**TOWN OF FRANKLIN
PENDLETON COUNTY, WEST VIRGINIA**

CONTRACT 1: WATER TREATMENT SYTEM IMPROVEMENTS

ADDENDUM #1

THRASHER PROJECT #D10-11026.00 (Dunn 1901)

SCALE: 1/2"=1'-0"

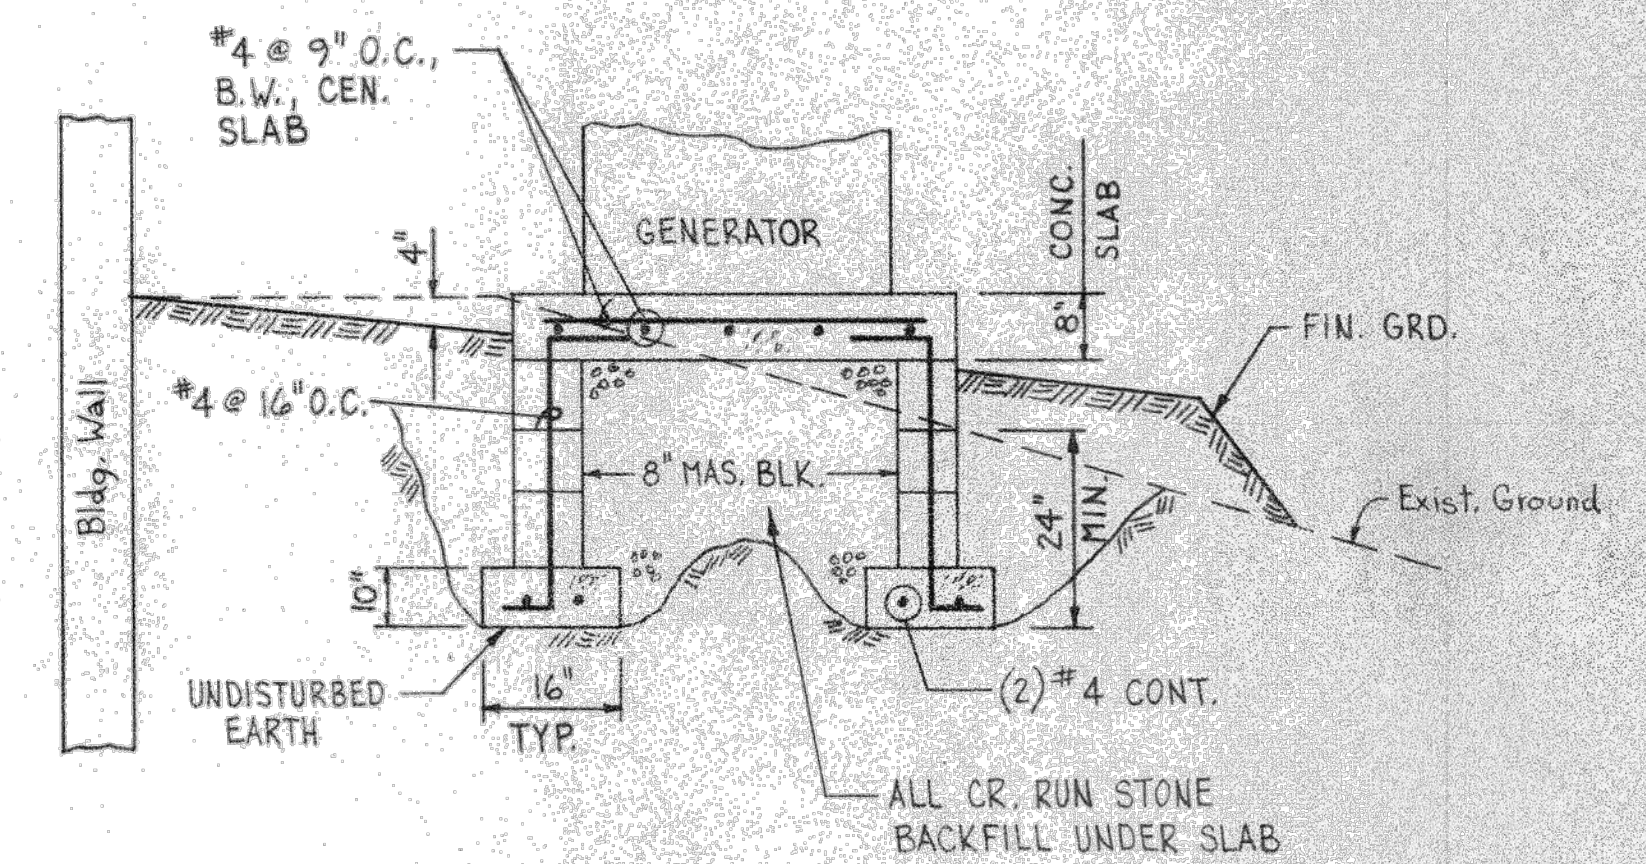
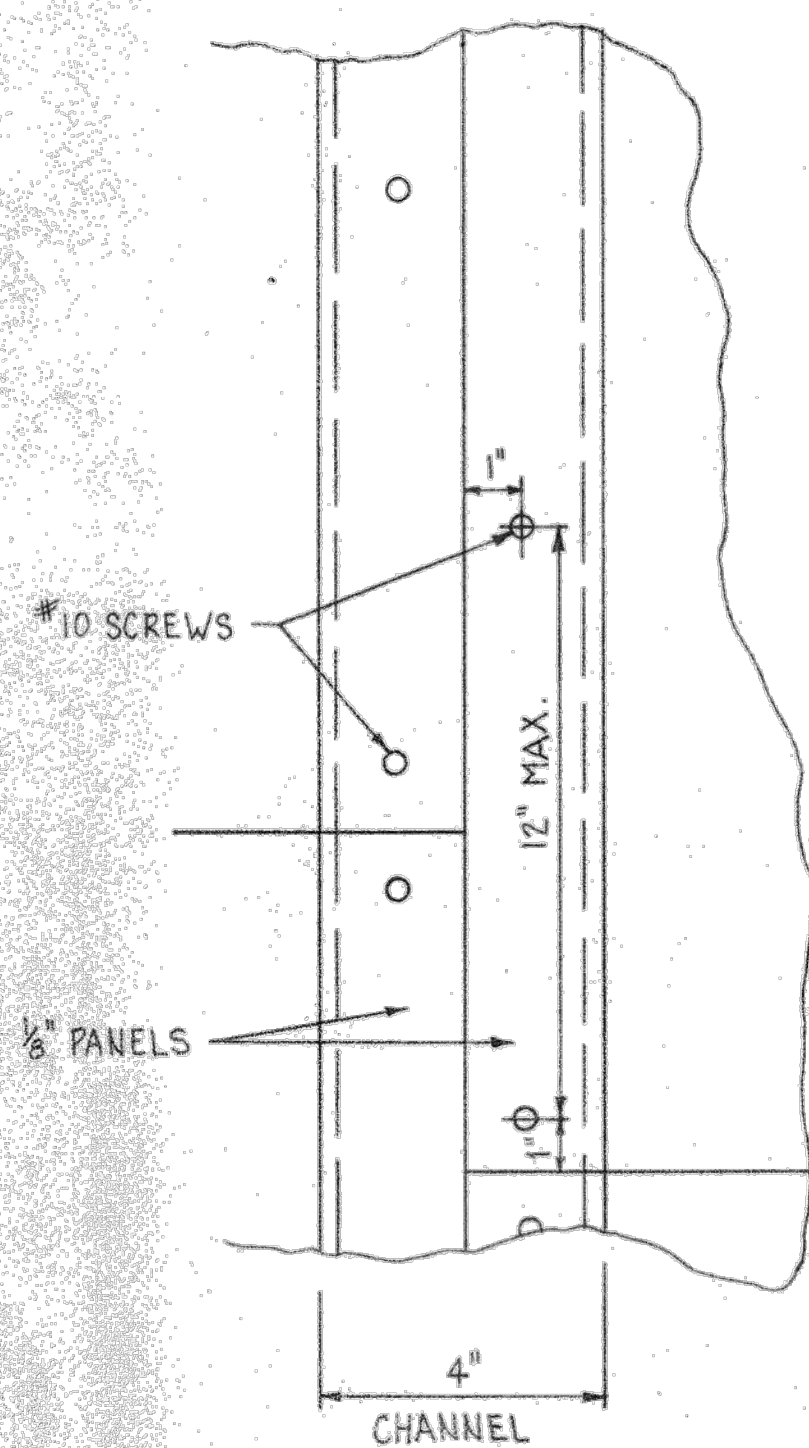
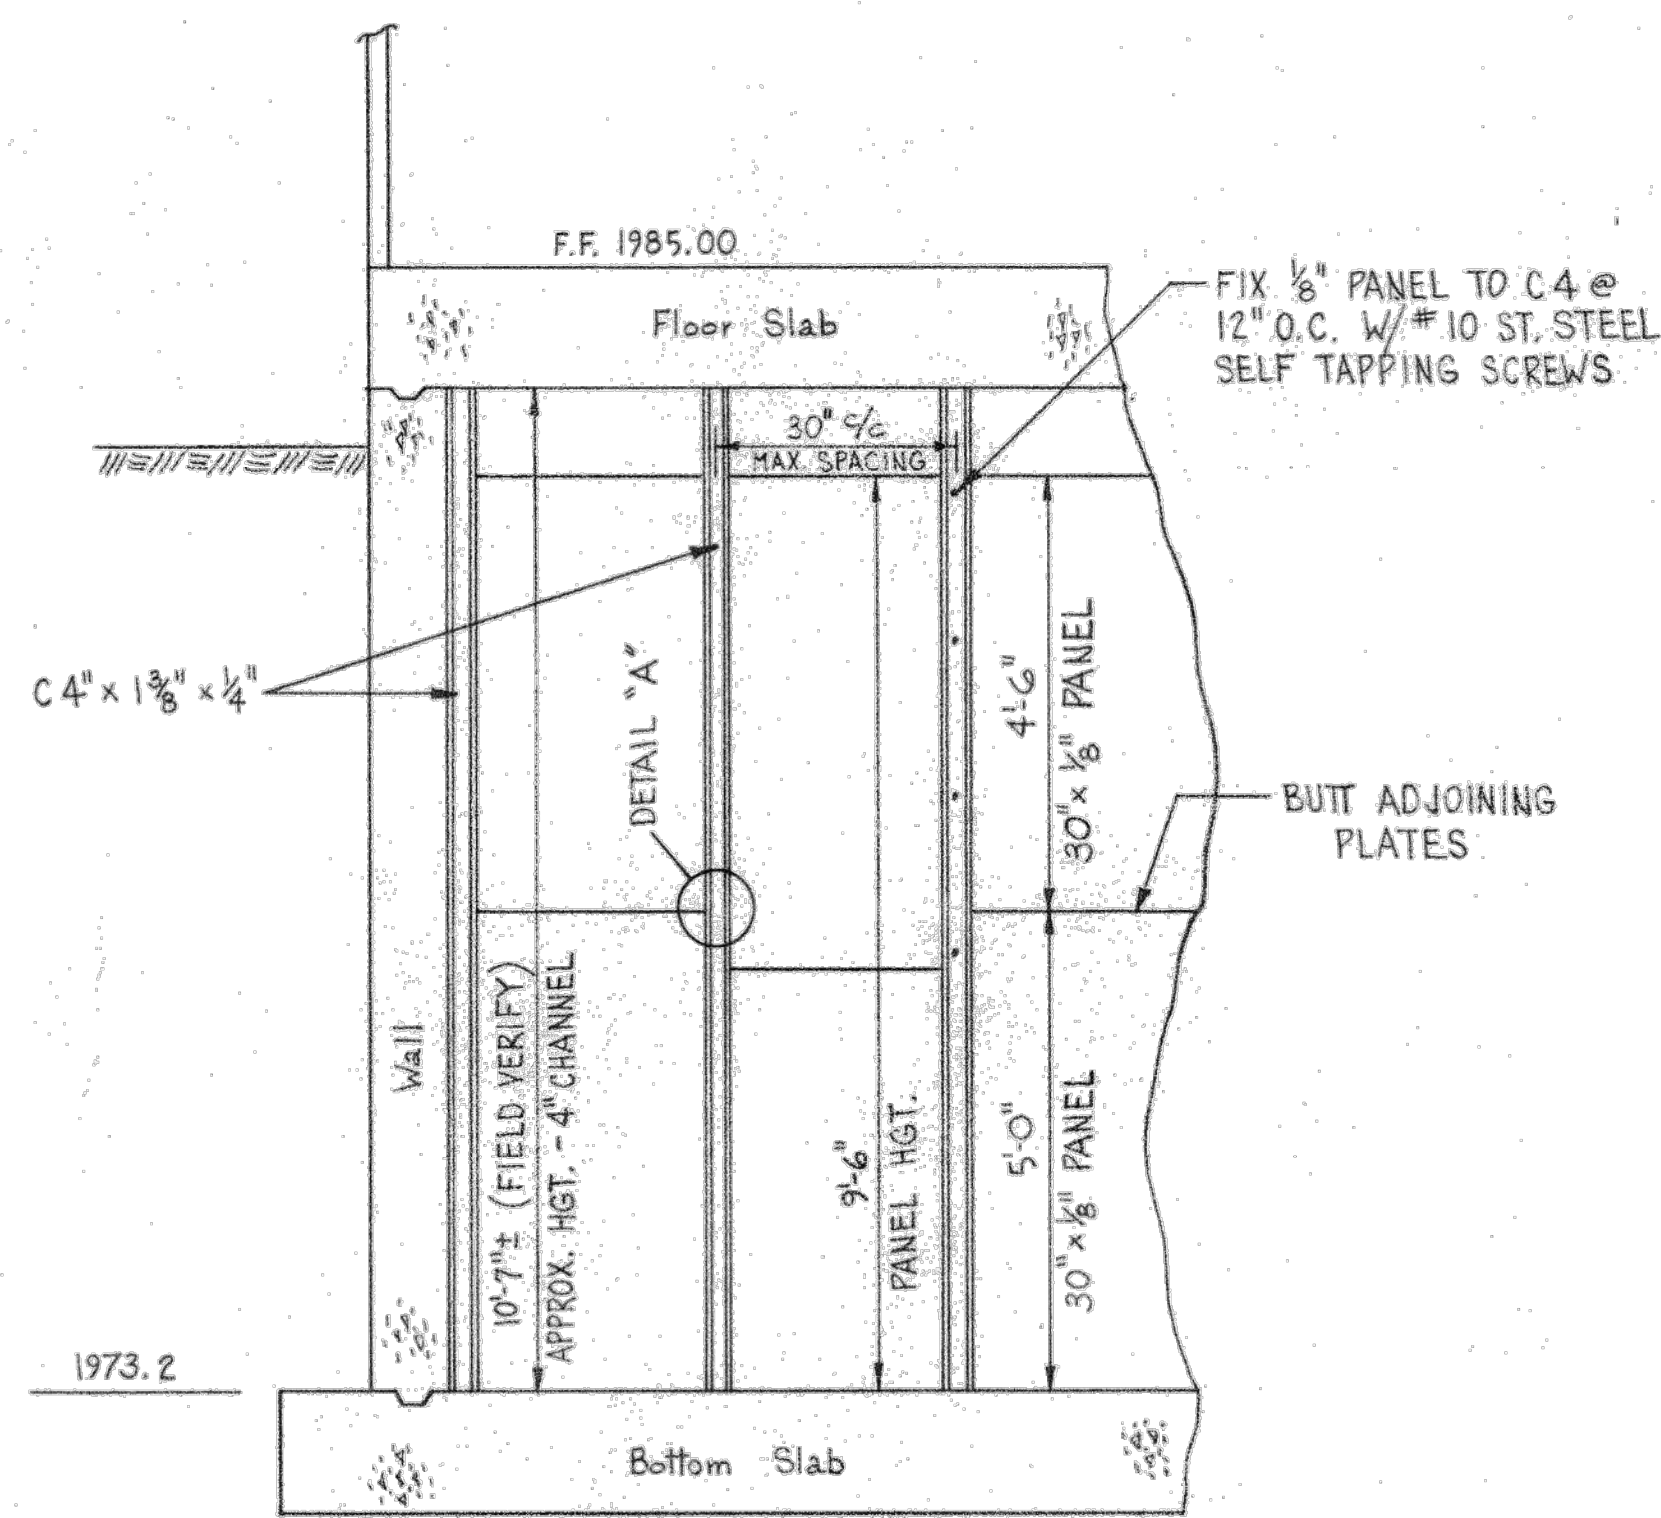
ADD Drawing 1901- 9H CLEARWELL BAFFLE AND GENERATOR PAD

18. Can we use Fiberglass Baffles in lieu of HDPE for the Clearwells?

Fiberglass Panels that are NSF61 approved may be used.
